ISSUED FOR CONSTRUCTION

LIFT STATION AREA 360 PLAN VIEW

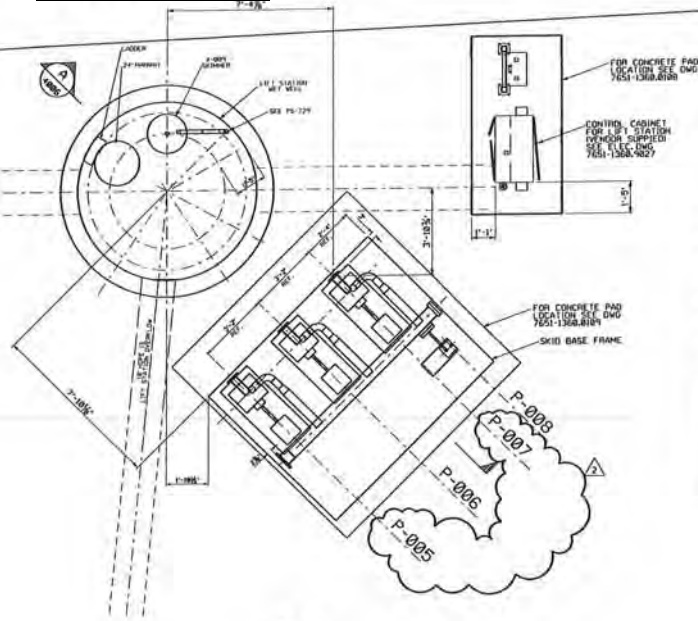
Electrical Classification Drawing 7651-1360.9070 shows the control panel (Item 37 as shown on this page), to be separate from the pumps on the skid. It also shows that the control panel, along with the Automatic Transfer Switch, will be mounted outside the Class 1 Division 2 area. The pumps on the skids will be located within the Class 1 Division 2 area. This control panel will need to be shipped separate from the skid and connected together on site as shown in the Electrical Area Classification Drawing.
